## **SERVICE LETTER: #72**

**TITLE:** 802 Air Tractor Float Longerons and Float Bracket Repair

**EFFECTIVITY:** All AT-802 aircraft with Wipaire 10000 Floats installed.

Figure 1

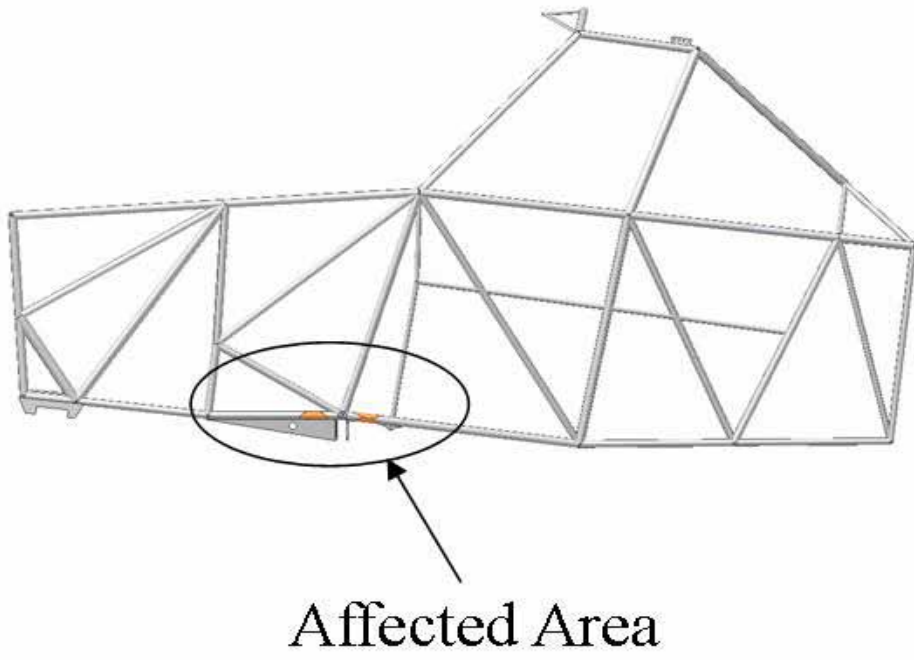
**Service Kit #51 is required** and consists of cutting an opening at the indicated place in order to have access to the effected area of the longeron and creating a permanent access panel for future inspections.

Figure 2

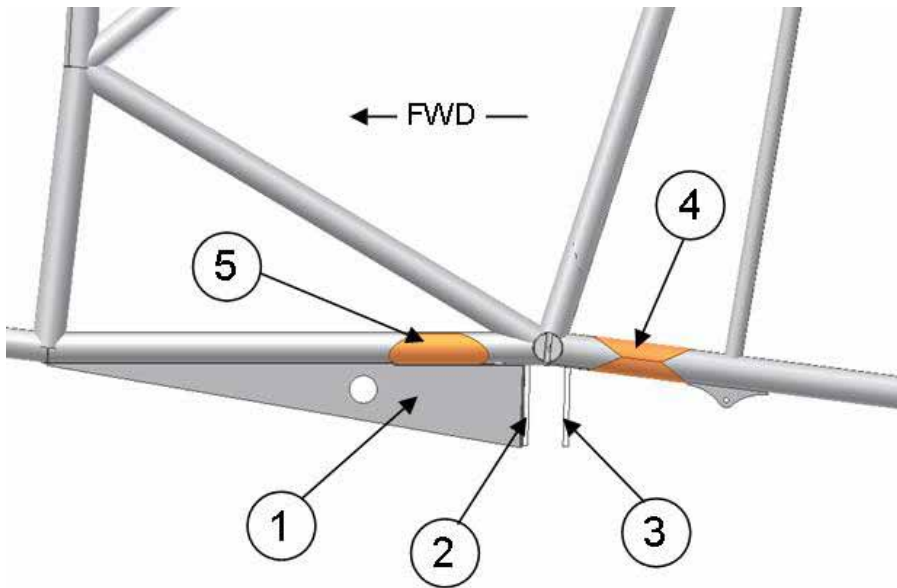
**Service Kit #52 is required** and must be done for compliance with this Service Letter. It consists of cutting a second panel from the skin and welding in a longer gusset (Figure 2, Item 1, Wipaire p/n 1001559, Air Tractor p/n SK574-2 or customer fabricated according to the drawing instructions).

Figure 3

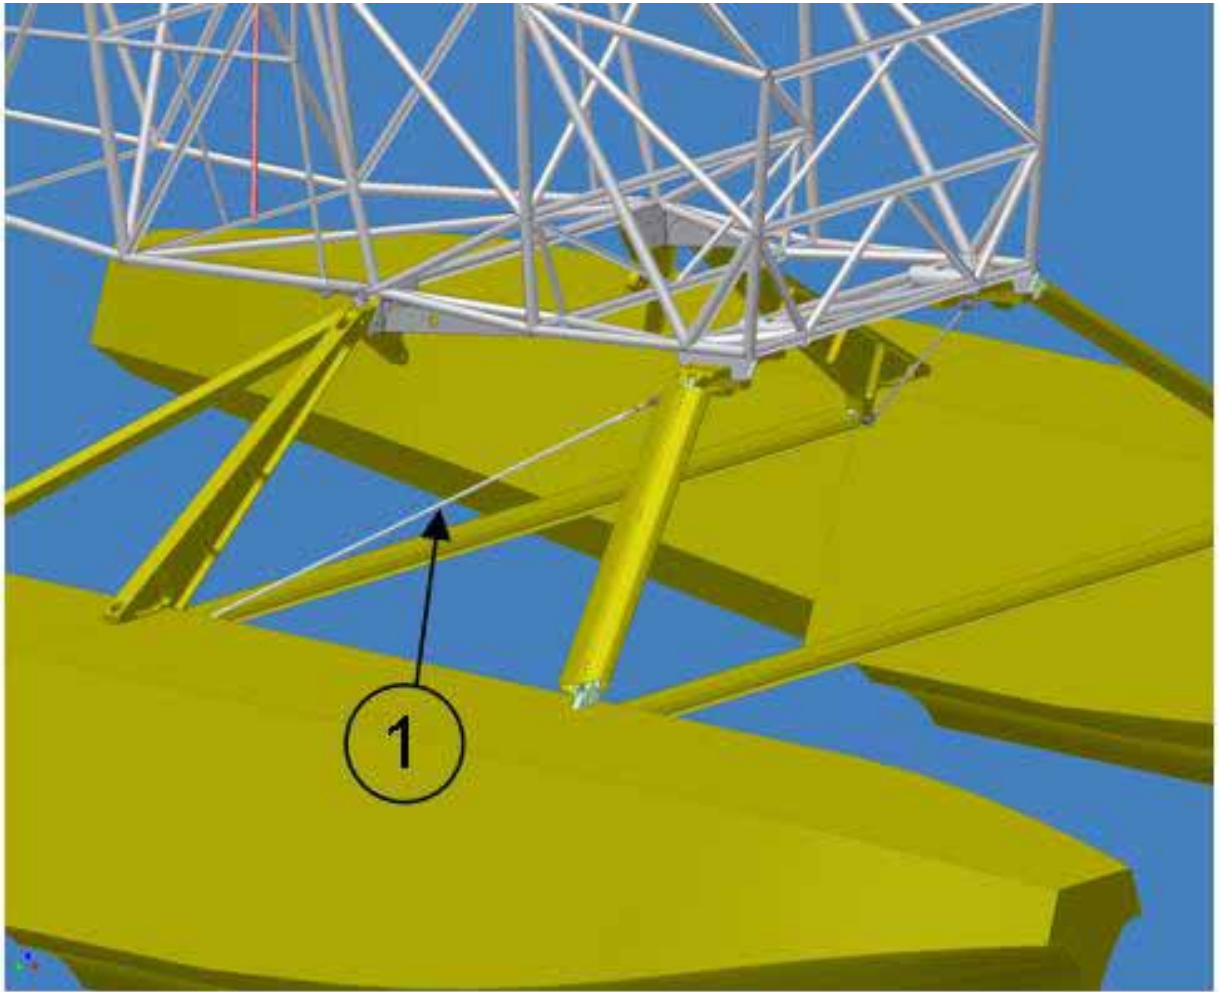
**Service Kit #53 has been determined optional.** It consists of adding tension wires as shown in Figure 3, Item 1, for load distribution reasons.
